PHASE 2 HVAC IMPROVEMENTS

**LP WILSON COMMUNITY CENTER
599-601 MATIANUCK AVENUE
WINDSOR, CT 06095**

S/P+A PROJECT #21.288

DATE: April 3, 2024

Drawing Title:
**MECHANICAL PLAN
 AREA B - PHASE 2**

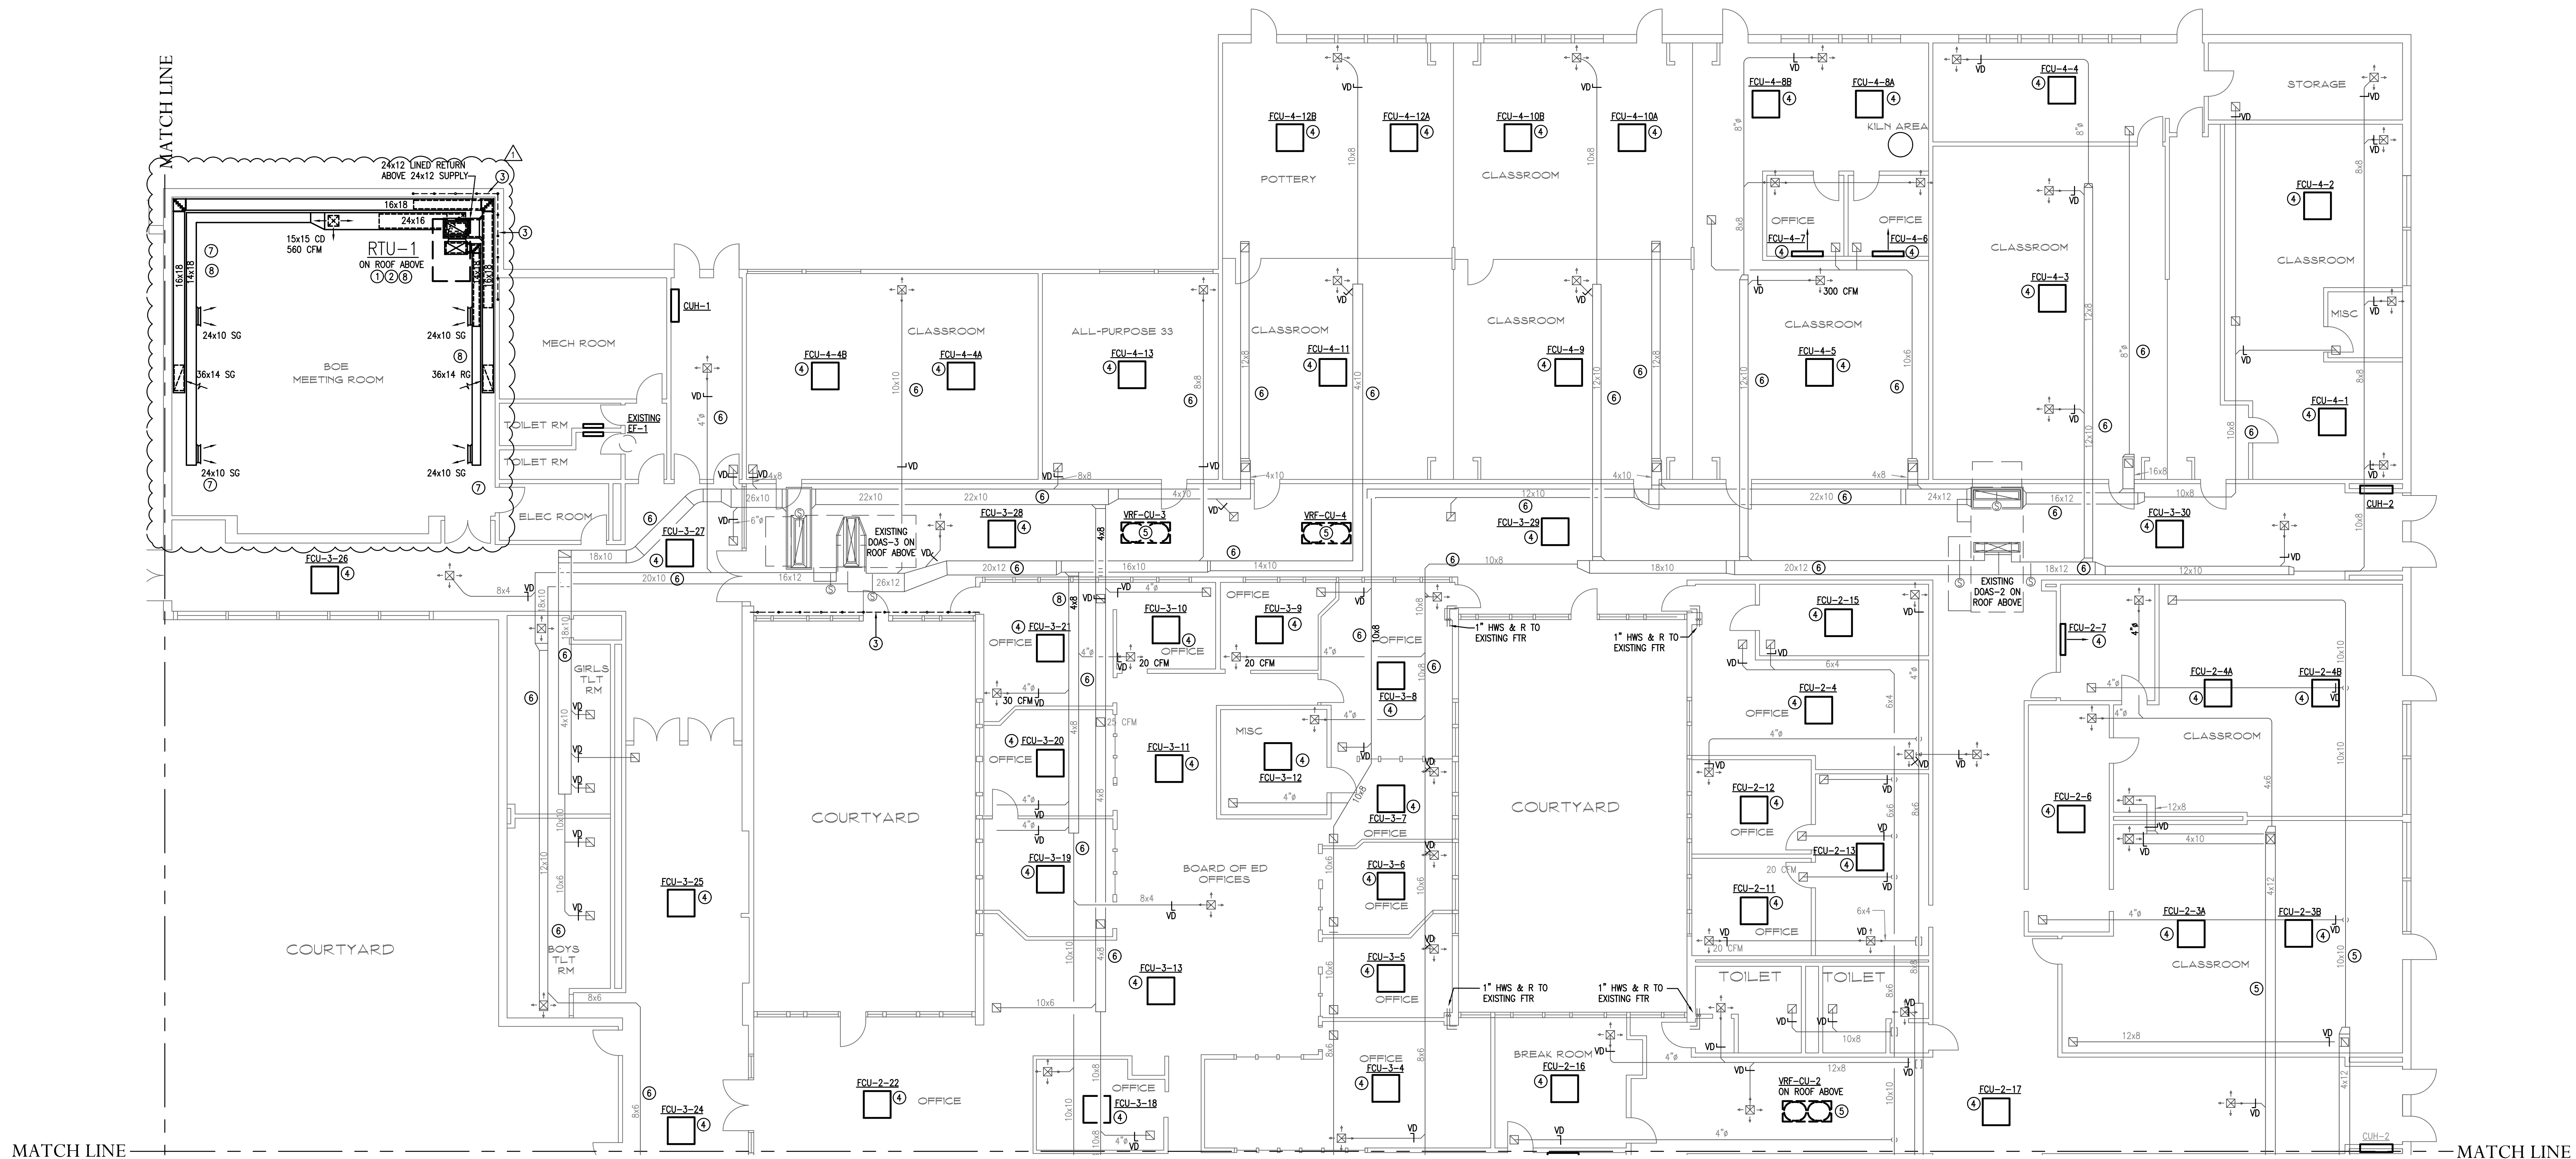
“ADD ALTERNATE #4: BOE Meeting Room Ductwork Replacement: Add to the Base Bid the labor, materials, and equipment for the removal and replacement of the existing duct system and associated components servicing the BOE Meeting Room (RTU-1) as indicated on Drawing M102. Work includes but is not limited to ductwork, diffusers, grilles, hangers, and devices for a complete installation. Work also includes the removal and replacement of the existing ACT soffit to conceal ductwork as well as patching and repairing existing walls and ceilings affected by this work to match existing.”

- ⑧ BOE MEETING ROOM BID ALTERNATE: IN LIEU OF CLEANING AND REUSING EXISTING DUCTWORK, REMOVE ALL EXISTING DUCTWORK AND INSTALL NEW SUPPLY AND RETURN DUCTWORK, GRILLES AND DIFFUSERS TO SERVE RTU-1 AS INDICATED. PROVIDE MINIMUM OF 10' LINED DUCT FROM UNIT INLET AND DISCHARGE, AND FLEX CONNECTIONS TO UNIT. REMOVE EXISTING SOFFIT AS REQUIRED TO PERFORM WORK AND INSTALL NEW SOFFIT TO CONCEAL NEW DUCTWORK. CEILING DIFFUSER SHALL BE TITUS MODEL TDC, 15x15, 560 CFM 3-WAY AIR PATTERN, W/ OBD. SIDEWALL SUPPLY GRILLES SHALL BE DOUBLE DEFLECTION TITUS 112RL, 24x10, 560 CFM W/ OBD. CEILING RETURNS SHALL BE TITUS 350RL, 36x14.
